[Picture\(s\) of Kenwood - TS-830](#)

## **TS-830S Frequency Shift**

Service Bulletin no. 840 (14-4-1982)

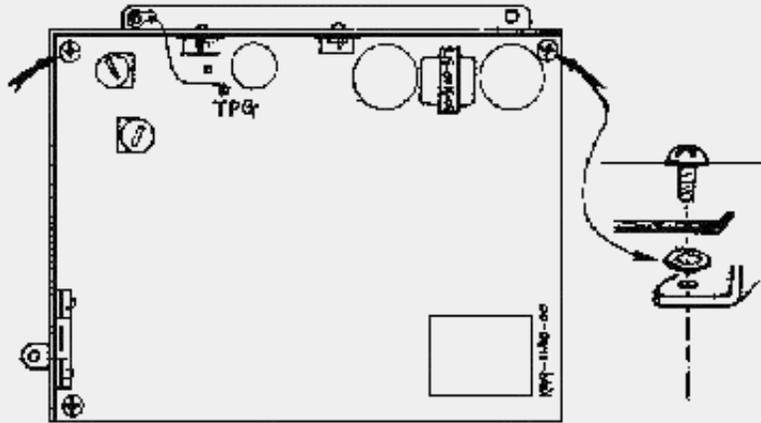
Some users may report an intermittent shift in the display and operating frequency. This may typically be a 1 to 4 kHz random shift. Cause will be a loose grounding screw on the AF/AVR unit heat sink.

On the AF/AVR unit X49-1140-00, there are three self-tapping screws holding the aluminum heat sink to the PCB. These also supply the ground connection to that section of the board. Between the heat sink and PCB foil, add a tooth-lockwasher N17-1030-41 at the two self-tapping screws on the side of the heatsink that has the two transistors attached. (The remaining screw already has a lock washer.)

When replacing the board to the chassis, add a solder lug E23-0420-05 to the heat sink mounting screw as shown, and tighten all screws for this board. Solder an insulated lead between the TPG (Test Point Ground) wrap post adjacent to C81, and the added solder lug.

1. Remove the top cover (8 screws) and unplug the speaker.
2. Remove the bottom cover (8 screws).
3. Remove 5 screws holding the AF/AVR unit and swing the board over. Leads do not have to be unplugged.
4. Add two tooth-lock washer as shown.
5. Replace the circuit board and heat sink to the chassis, adding the solder lug as shown.
6. Solder a jumper between the TPG wrap post and the added solder lug.
7. Replace the top and bottom covers.

Service Bulletin no. 837 (15-12-1980)

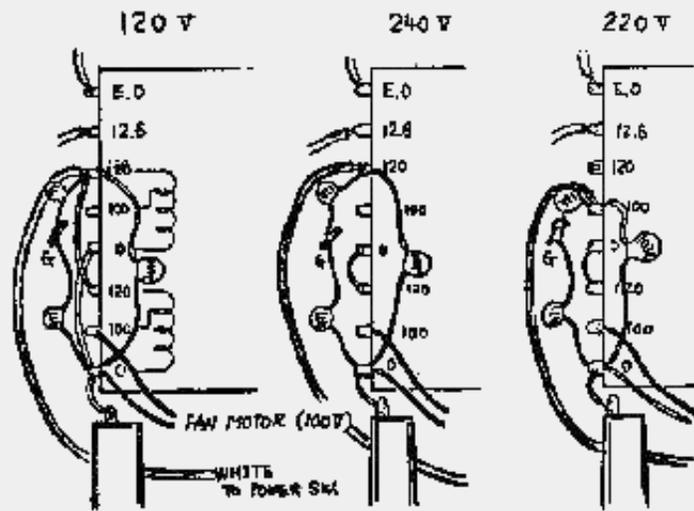
To operate the TS-830S on 240V AC, the power transformer split primaries must be rewired from parallel to series connection.

1. Unplug the AC power cable.
2. Remove the bottom cover.
3. Remove the jumper wires between the two  $\emptyset$  terminals and two 120 terminals on the bottom of the power transformer.
4. Connect the adjacent 120 and  $\emptyset$  terminals at the middle of the transformer. This will provide 240V AC operation.

For 220V AC operation, connect the adjacent 100 to  $\emptyset$  winding.

5. Change the AC fuse from 6A to 4A. Tag the power cord at the back of the radio to indicate that the transformer is strapped for 240V AC, and the power fuse should be 4A, and not 6A.
6. Replace the bottom cover and reconnect power to verify your work.

## TS-830S Noise Blanker Optional Improvements

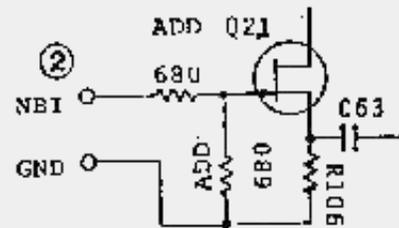
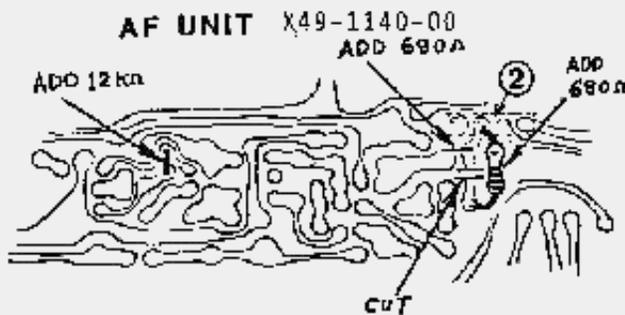
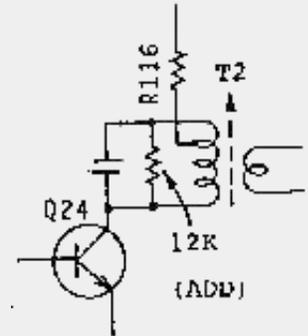
Receiver Cross-modulation while using the noise blanker may be improved by these optional component changes and additions. Realignment is not required.

At the Noise Blanker level control VR8, change R19 from 22 ohm to 15 ohm (RD14BB2E150J)\*

On the AF AVR unit X49-1140-00 (vicinity of Q20) change:

D22 from an MV-13 to an MV-203 (VII-3379-16)\*

R96 from 2.2 Kohm to 820 ohm (RD14CB2E821J)\*

R112 from 47 Kohm to 56 Kohm (RD14CB2E563J)\*

Across T2, (Fig. 1) add a 12 Kohm (RD14CB2E123J)\*

At Q21 (Fig. 2,3) add 2 pcs. 680 ohm (RD14CB2E681J) \*

**TS-830S Transmitter "Talkback"**

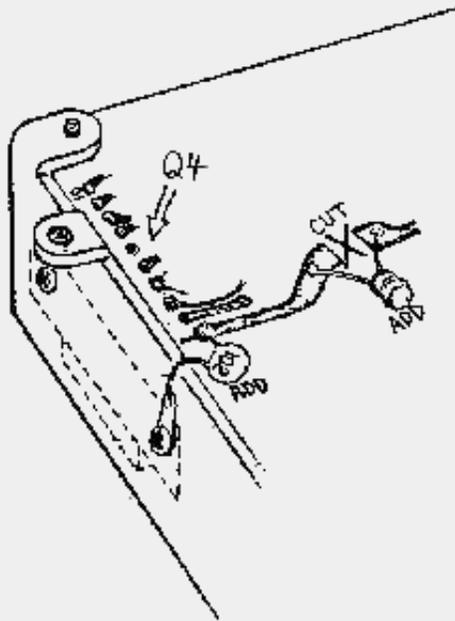
Transmitter "talkback", either with or without a linear amplifier, may be eliminated by adding a filter at

the receiver audio power amplifier.

On the AF unit X49-1140-00 at Q4, cut the 12V DC B+ line between R47 and C28, and add a 1uH choke (L40-1092-02) in-line. Add a .01uF cap (C52-1710-36) from the IC pin 1 to ground, as shown using a 3 mm lug (E23-0015-04) under the IC mounting screw on the Heat Sink.
